10/797,581

### Office Action Summary

This is the seventh Office Action for serial number 10/797,581, Computer Workstation With Moveable Monitor Support, filed on March 10, 2004.

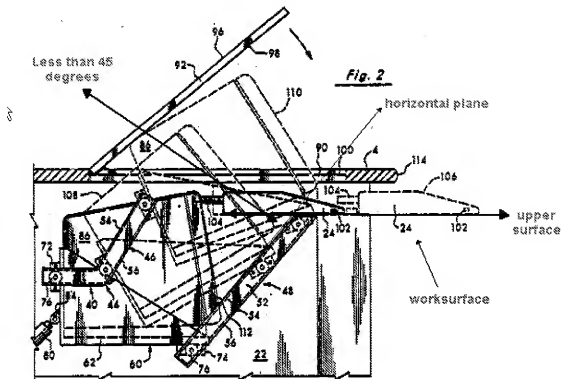
Price '773 discloses a computer workstation comprising: a worksurface (24) moveable a first distance in a fore-and-aft direction between first and second worksurface positions; wherein a support surface of the worksurface forms an angle between about 5 to 45 degrees with a horizontal plane (see Figure 2 below); a monitor support (60) coupled to the worksurface, wherein the monitor support is automatically moveable in response to a movement of the worksurface, wherein the monitor support automatically moveable a second distance in fore-and-aft direction between first and second monitor positions in response to the worksurface being moved the first distance between the first and second worksurface positions; wherein the second distance is greater than the first distance; a base (desk) having an upper surface formed at substantially with the horizontal plane, and wherein the base supports the worksurface.

Furthermore, Price '773 disclose wherein the monitor support defines a support place (62) and further comprising at least one track oriented non-parallel (40, 42) to the support plane, and a guide (76) moveably mounted on the track, wherein the monitor support is pivotally connected to the guide; wherein the worksurface is connected to a front of the monitor support; and wherein the at least one track comprises at least one first track (46) directed upwardly from a rear to a front thereof and at least one second track (44) directed downwardly from a rear to a front thereof; wherein the second track is positioned forwardly of the first track and further comprising a first guide (76) moveably mounted to the first track and a second guide (76) moveably mounted to the second track, wherein the monitor support is pivotally connected to the first and second guides, wherein the monitor support rotates about a horizontal axis as the first and second guides are moved along the first and second tracks respectively.
